Re: Sandy Acres Pit, DRMS Permit No. M-1980-110  
Technical Revision 6 (TR6) additional information

RE: Hendersen Development / Sandy Acres, Permit No. M-1980-110, Technical Revision (TR-06), Response to Request for Additional Information

This letter provides a response to the Division of Reclamation, Mining and Safety's (DRMS) April 18, 2024 request for additional information associated with Technical Revision 06 (TR-06) for Permit No. M-1980-110 to address issues of concern and allow the revision to be considered for approval.

**Figure 1**  
**E-470 Sandy Acres Pit**  
**General Location Map**

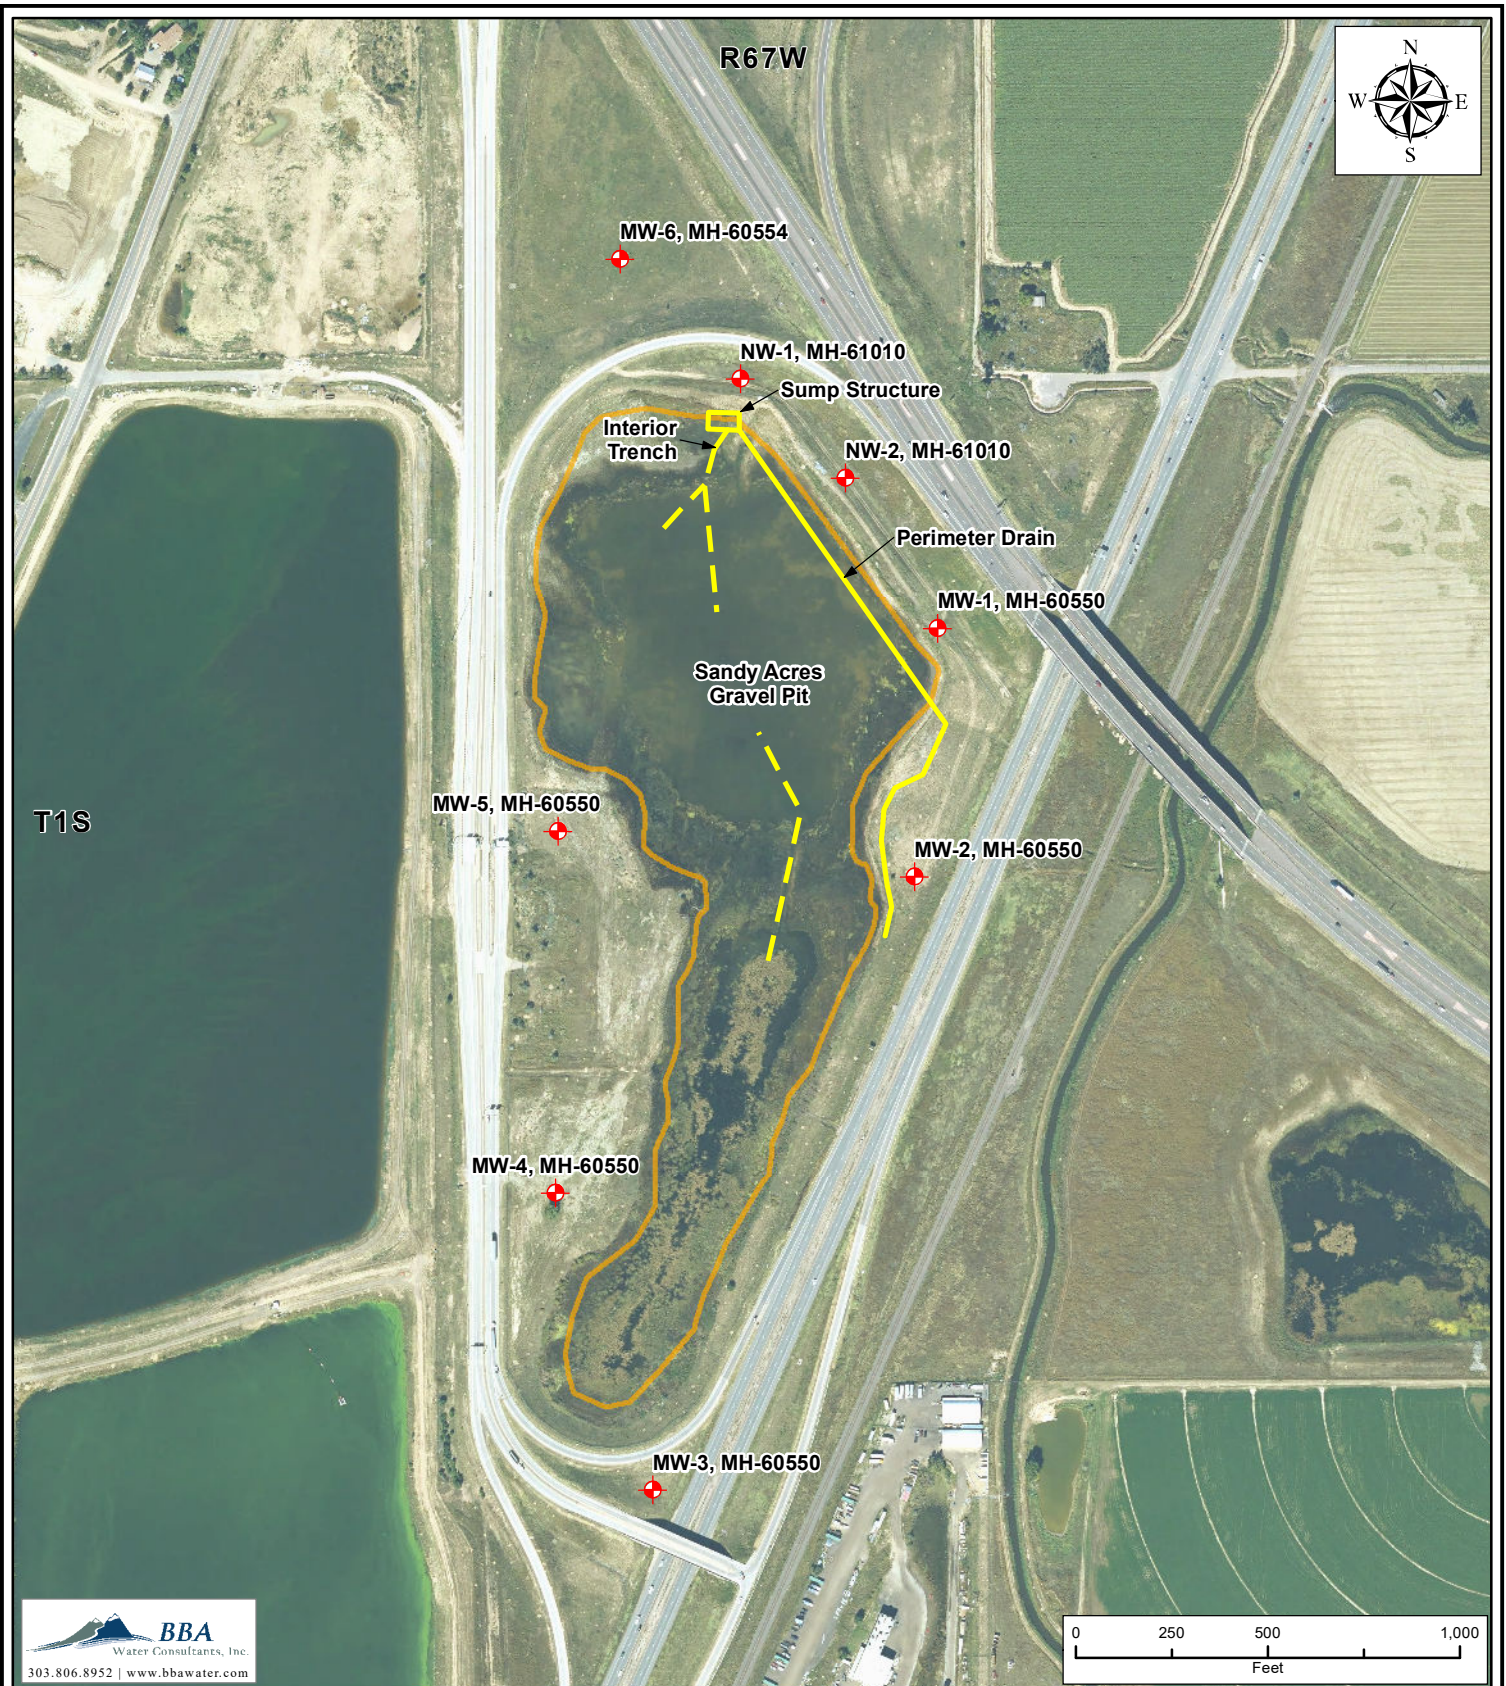
- Confirm whether the initial perimeter drain structure was installed consistent with TR-05, when the installation occurred, what observations were made during the installation and whether BBA Water Consultants, Inc. (BBA) were onsite during the installation.
- Provide additional information regarding the northeastern portions of the perimeter drain structure (trench and sump) that appear to be installed in non-native or fill material.
- Confirm whether the trench and sump portions of the drain system in the northeastern portions of the pit were installed in accordance with TR-05.
- Provide as-built drawings of the perimeter drain.

The location of the initial trenching, the sump structure and the extended / connected trenching along with the interior ditch efforts have been presented in the attached Figure 1. A cross section of the drainage system trench construction is provided in the attached Figure 2.

# Figure 5

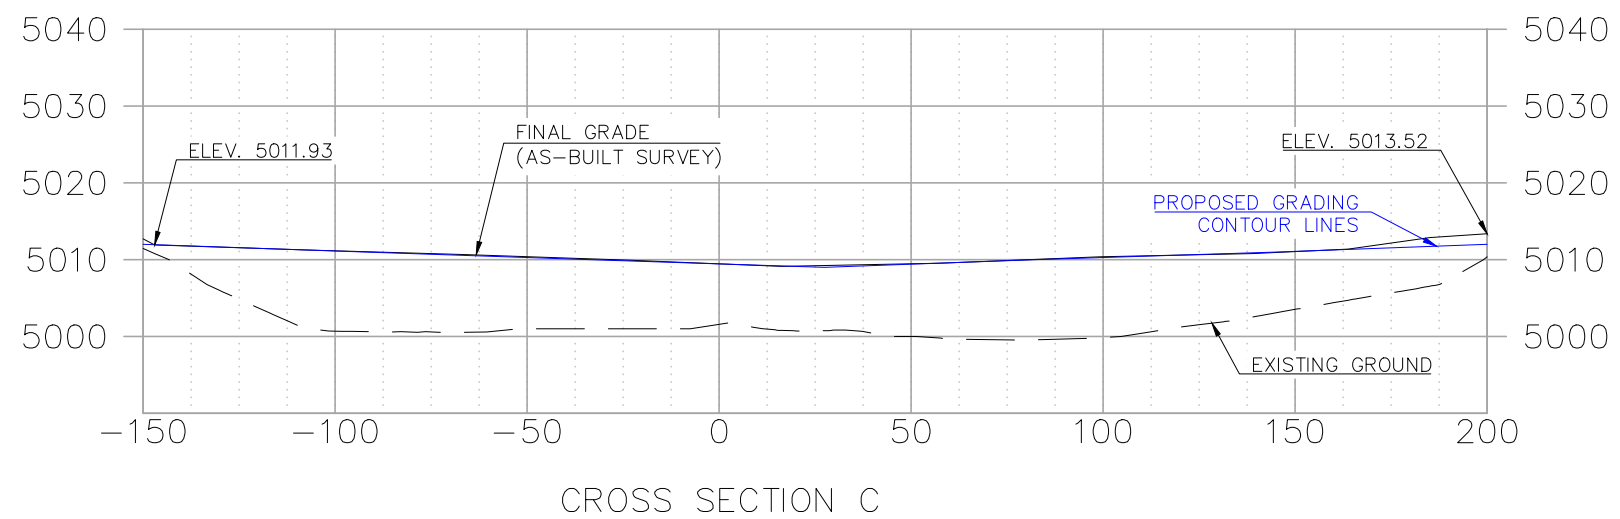
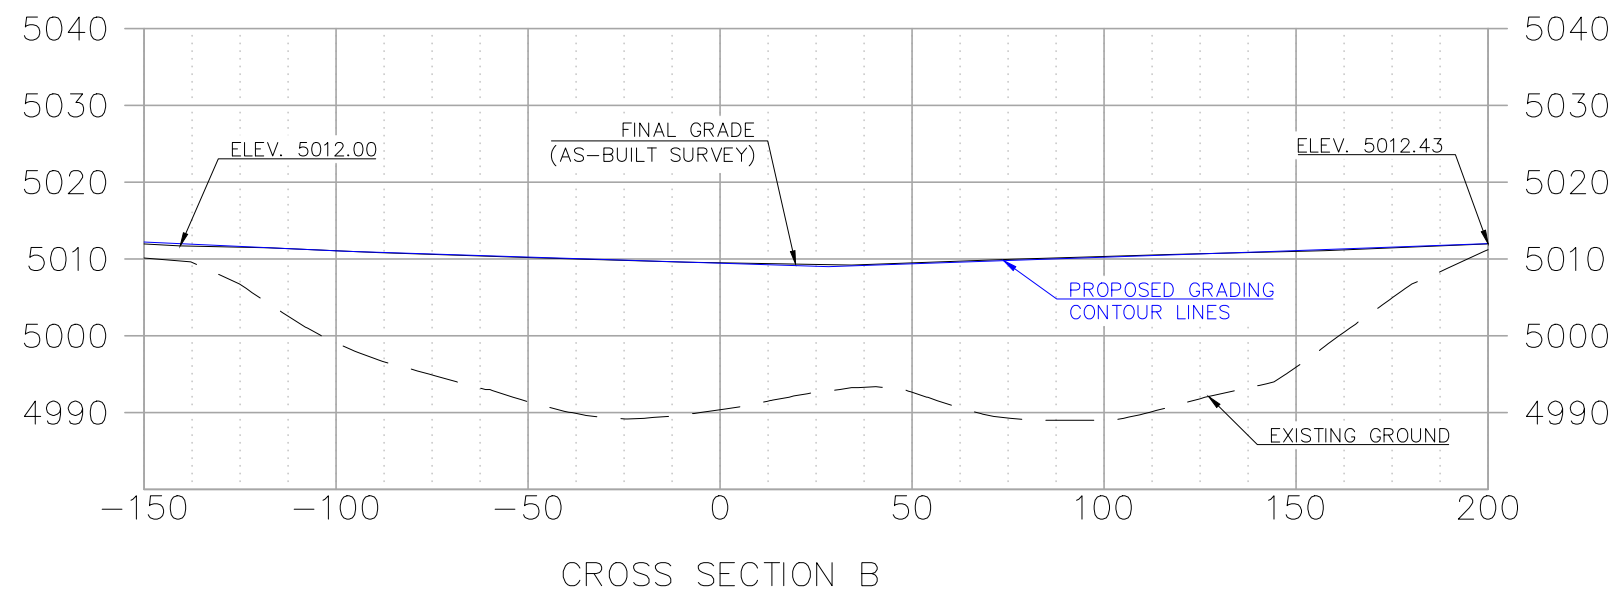
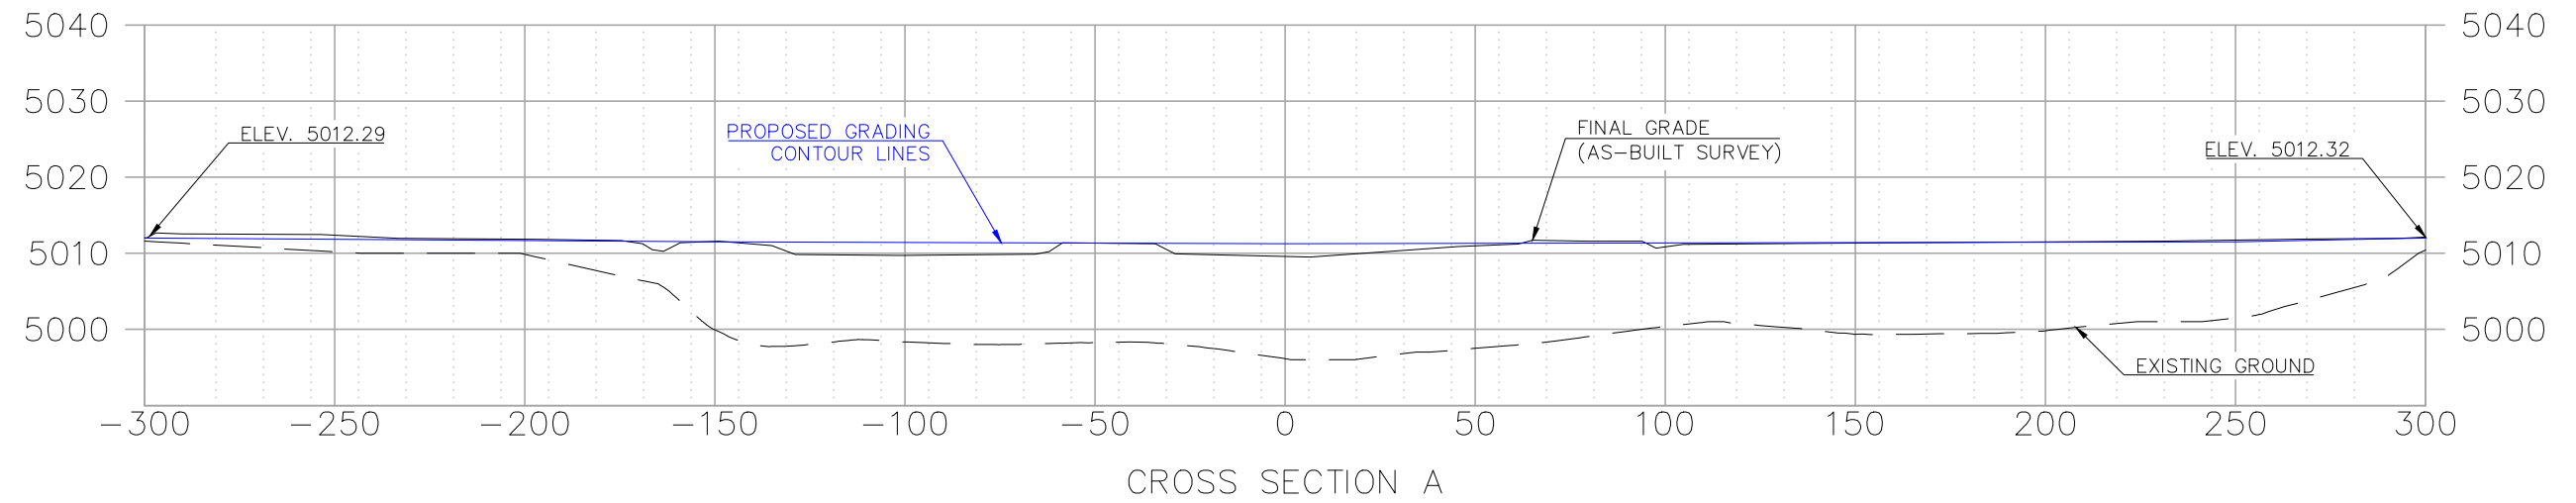
- Survey data / elevations for the installed pit backfill.
- Confirmation of the static water level used to determine the required backfill.
- The amount of fill that was added in relation to the identified static water level.

Survey data of the pit backfill was previously provided to the DRMS, but we understand that the as-built information provided may have been difficult to identify / read. The as-built pit backfill information was provided as three surveyed transects that were collected across the pit after the installation of the backfill. Accordingly, the survey data represents the elevation of the pit backfill at the time it was installed. The transects were provided on a general location map that included both the proposed and installed pit backfill elevations. The presentation of both the proposed and

The general location map that presents both the proposed and as-built pit backfill elevations has been represented as the attached Figure 5. As indicated in the attached figure, the as-built elevations are at least the proposed elevation of 5012 feet at the edges of the pit and at least the proposed elevation of 5009 feet in the center of the pit. Accordingly, based on the information that has been provided by E-470 for our review, the pit backfill was installed in accordance with the proposed grading plan.
